RFI 57

Project: COOLEY LABORATORY RENOVATION
Job: 3146 COOLEY LAB, PPA# 10-0023
Customer: STOFMT MSU BOZEMAN

Item: HELICAL PIER AT ARC ENTRANCE

2 PARTIAL FLOOR PLAN 1
 SCALE: 1/4"=1'-0" NOTE: SEE S2.1 FOR PLAN NOTES

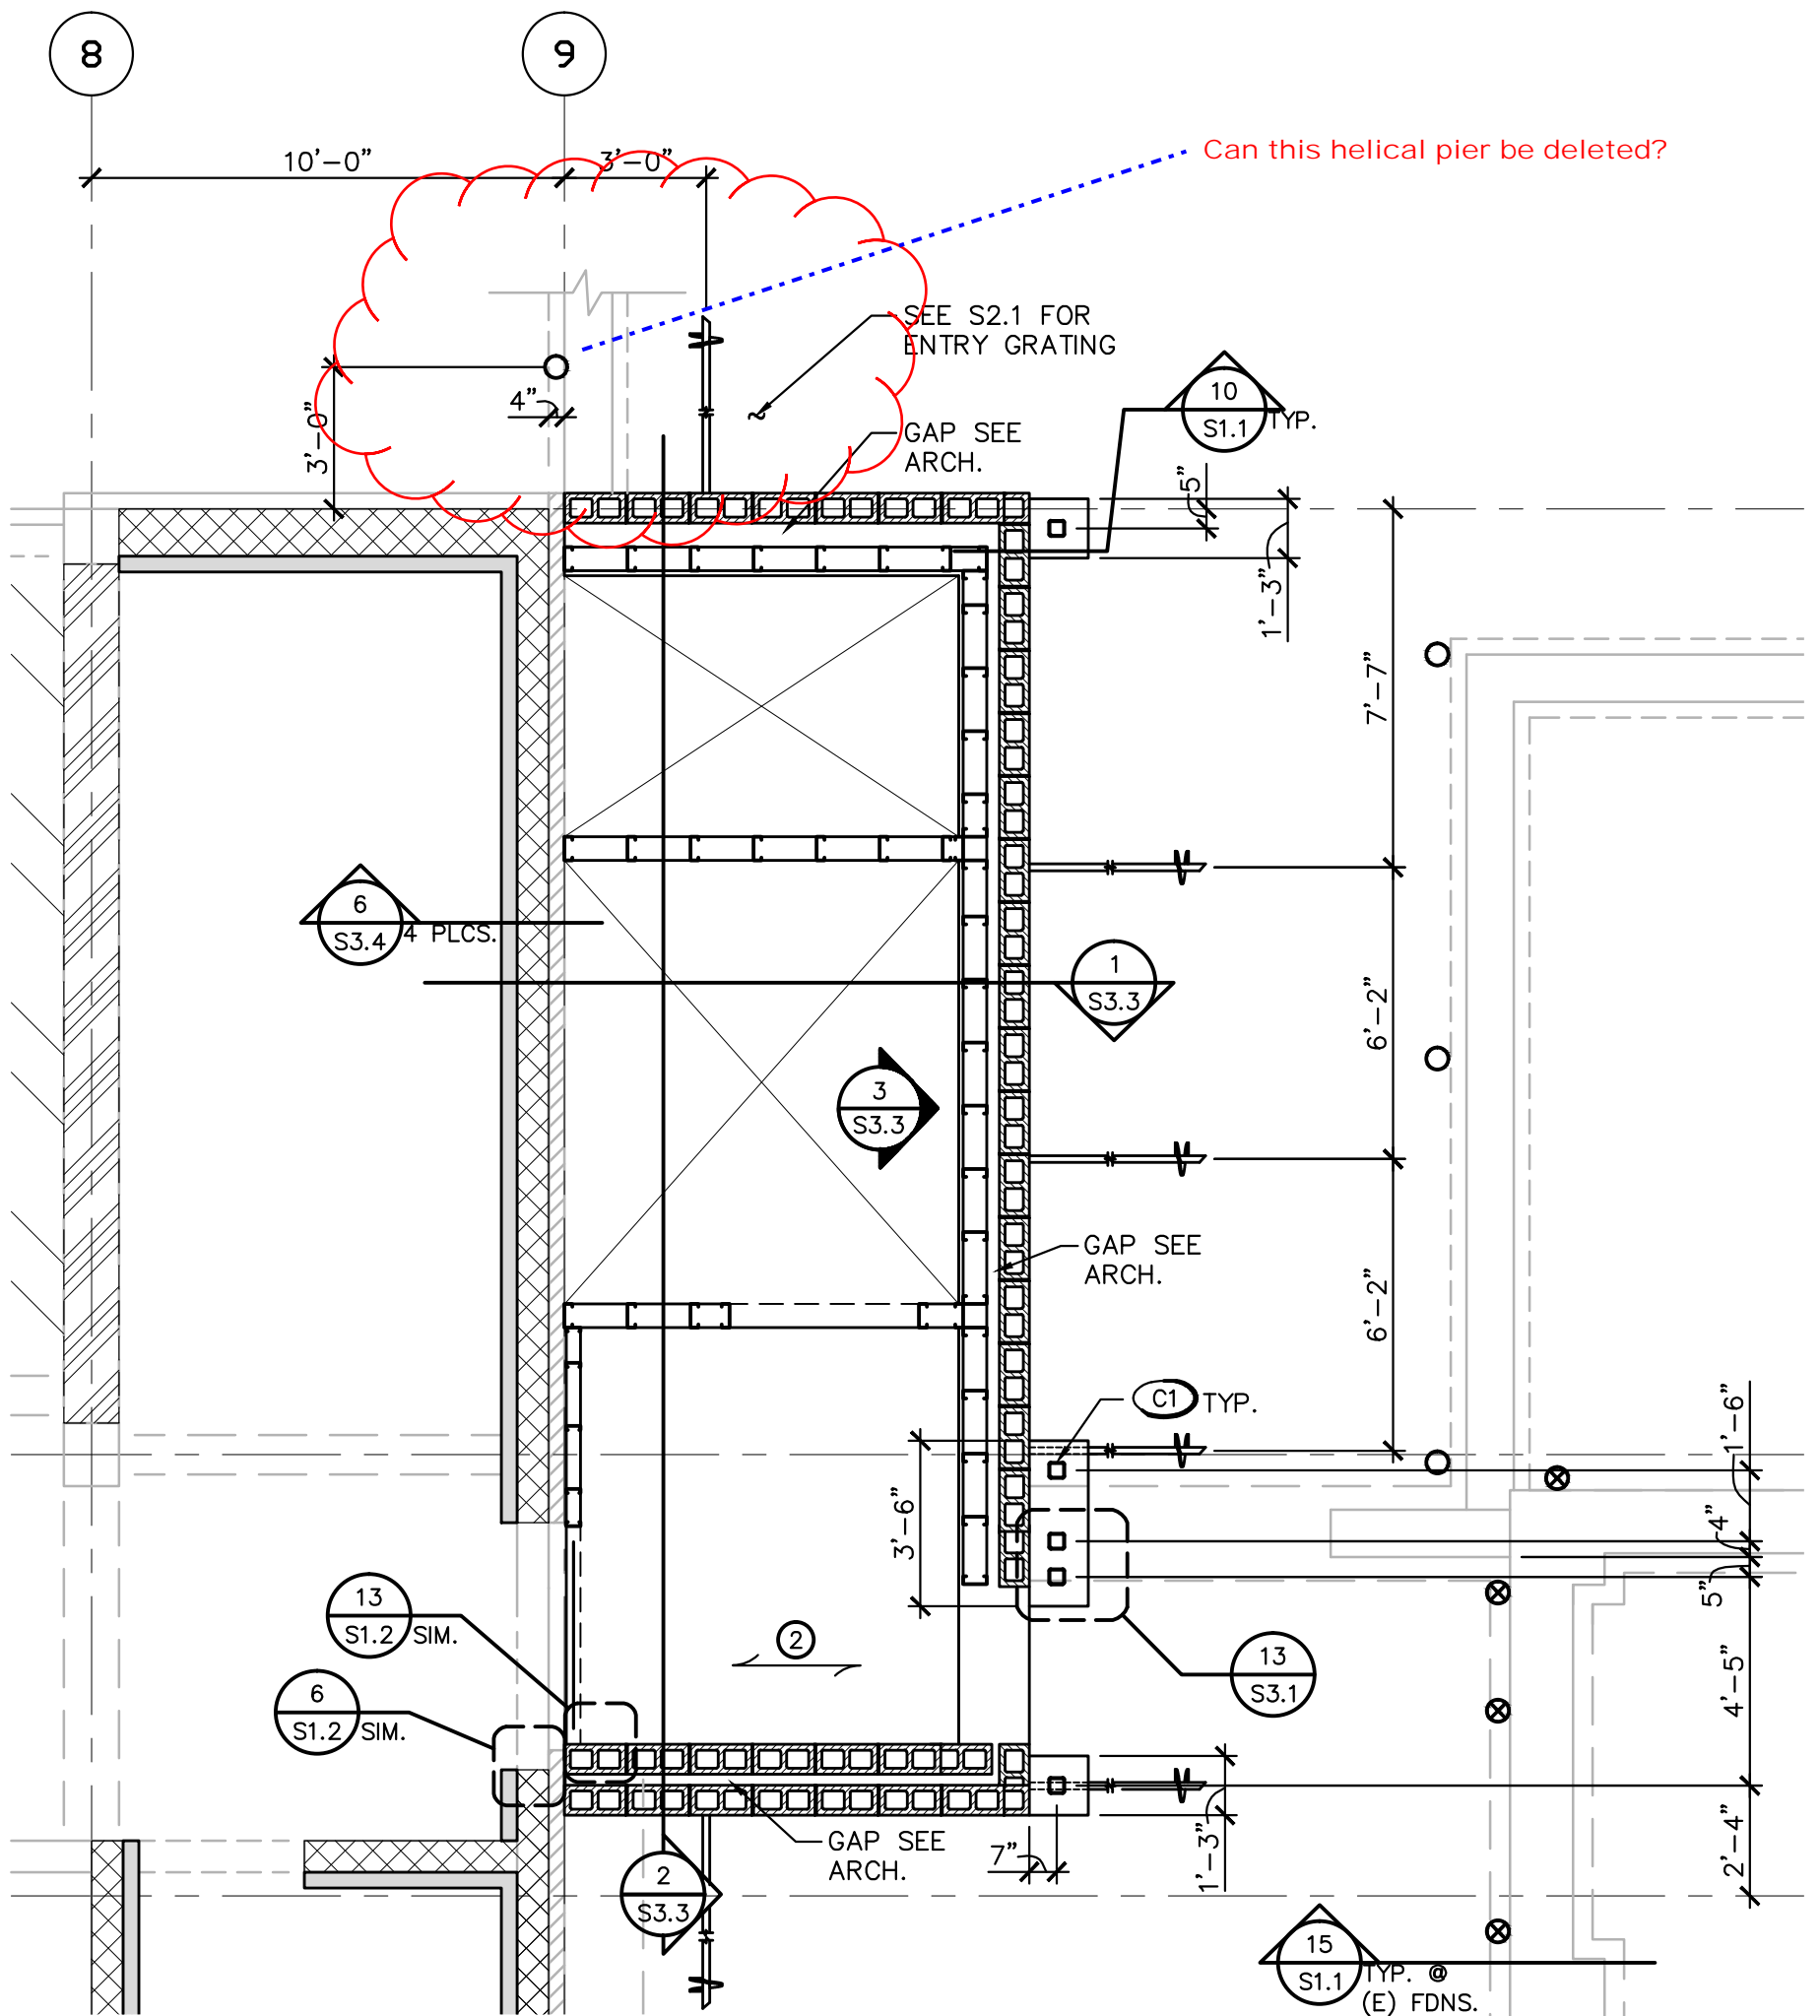
The helical pier shown at the entrance to ARC on 2/S2.7 (see attached), has not been put into place, is this helical pier for support of ARC foundation during excavation so undermining of foundation does not occur? The foundation excavation is already below the existing ARC foundation and has been shored. Is this helical pier still needed?

Can this helical pier be deleted?

For your reference I attached a scan of the soils report showing the extent of where they recommended shoring the existing structure. However, if everything is already shored and stabilized, I don't see a reason that it needs to be installed.

Credit for not installing the helical is due the owner.
